Oakley City Planning Commission Staff Report

PRELIMINARY PLAT: PUBLIC HEARING **River Haven Subdivision/Master Planned Development** **Applicant: Trevor Williams**

To: Oakley City Planning Commission
From: Stephanie Woolstenhulme, City Planner
Date of Meeting: May 3, 2023
Type of Item: Preliminary Plat – Possible Action
Process: Administrative Review

1. Preliminary Plat Plat
2. Architectural Design
3. Exterior Materials
4. Community Features
5. Citizen Comment/Question

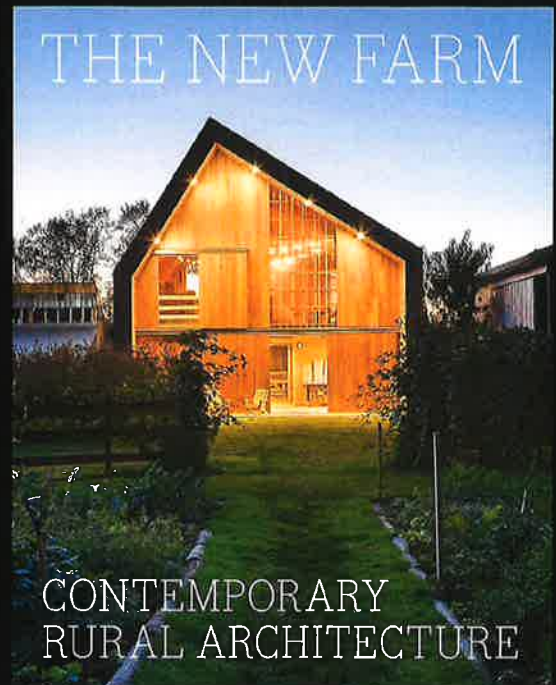
City Engineer would like road to be an asphalt width of 20', 2' shoulder either side, 3.5' swale on either side = total right-of-way width 31' – plat currently drawn at 32' ROW. Concern with street parking and still allowing ingress/egress and area for snow removal.

1. Access to City water on West side of Millrace Road (6" line). Water line will enter from Millrace road, following subdivision road, and dead end. Width of line to-be-determined, most likely an 8" line. Hydrants installed at appropriate distances.
2. City Sewer on East side of Millrace Road. Sewer will need to be evaluated for appropriate slope.

Based on the conceptual design plat, Lot 103 will be next to our fence.

Mr. Williams did have a trench dug behind the Oakley Polar King to help with this however, water still collects along the fence line of the proposed subdivision. How will Mr. Williams address this?

How close to our fence line will a structure be placed?
